November 3, 2011

**SUBJECT: Rebuttal of Comments on Cease and Desist Order NO. R5-2011-xxxx Requiring the City of Colfax Wastewater Treatment Plant Placer County to Cease and Desist from Discharging Contrary to Requirements.**

**POND No. 3 LINING PROJECT**

**Figure 1: Difference Between Measured and Calculated Change in Storage per Calendar Month.**

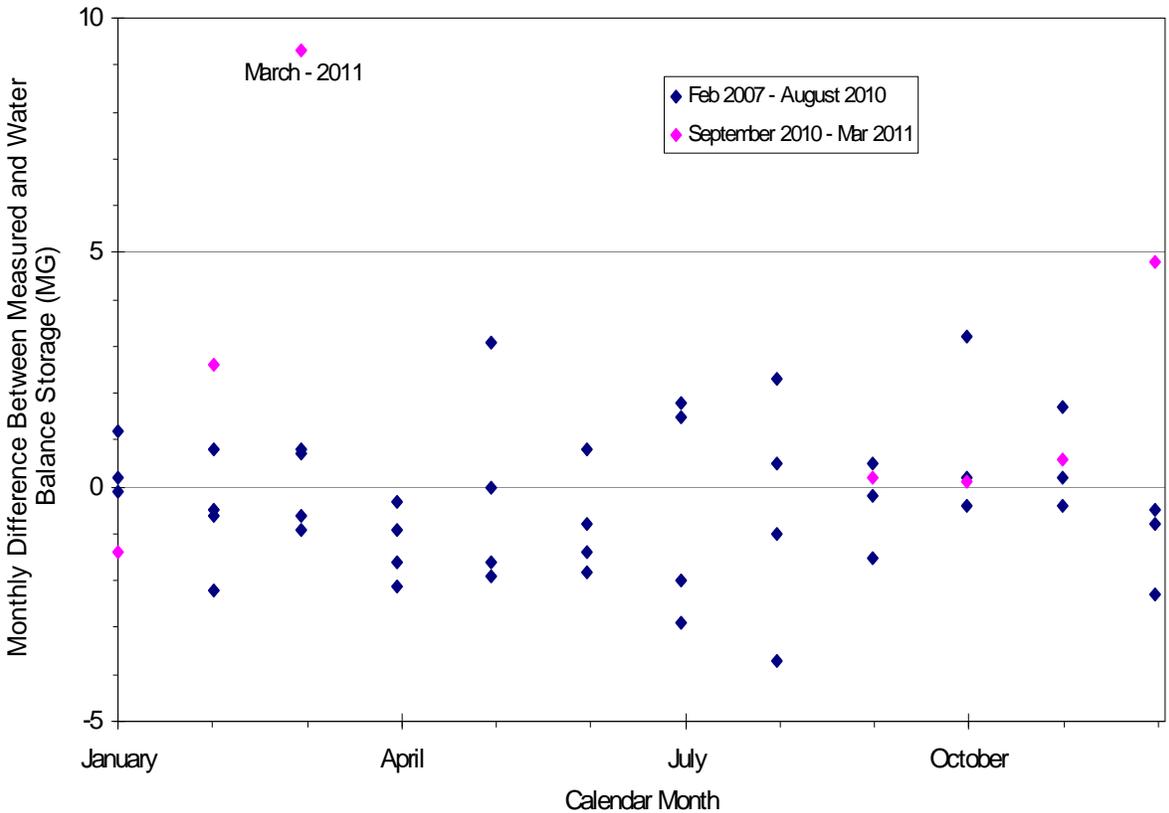
The Edwards Family Farm contends that the seepage into the pond is more significant than thought by the City because of the postulated high levels of seepage from the pond. However, the City intends to line the pond, blocking seepage from entering the pond; the channel parallel to Pond 3 has been relined and geologic investigations are planned to determine if there is seepage under the channel into the pond. The Edwards contend there may be an additional 3 MG per year of water to treat, but that would equate to an additional 0.008 MGD, which is within the error of the analysis. The Edwards point out that for June and July 2008 the water balance is “short” approximately 1.5 MG per month, however the June and July 2009 are calculated to have an extra 0.8 and 1.8 MG, respectively. The differences in monthly totals are within the error of the model.

The City is lining Pond 3 as a means to comply with Permit Discharge Prohibition III.A and prevent any leakage that is not currently captured. In the process of developing the August 2011 water balance, the calculated change in pond volume was compared to the measured change in pond volume. A plot of the difference between the measured monthly change in pond volume compared to the water balance calculated change in the monthly pond volume is presented as Figure 1 (Figure 13 in the August 2011 water balance report). As stated in the water balance report, there is an average of 0.25 MG per month (less than 0.01 MGD) loss from the reservoirs. Additionally, there is generally a  $\pm 3$  MG difference between measured and calculated monthly change in storage volume, corresponding to  $\pm 4\%$  of the available storage volume. Additionally, there are no apparent substantial systematic errors, especially in the July through September time period where conditions are driest. If there were significant levels of water seeping out of the ponds the pattern would be evident on Figure 1.
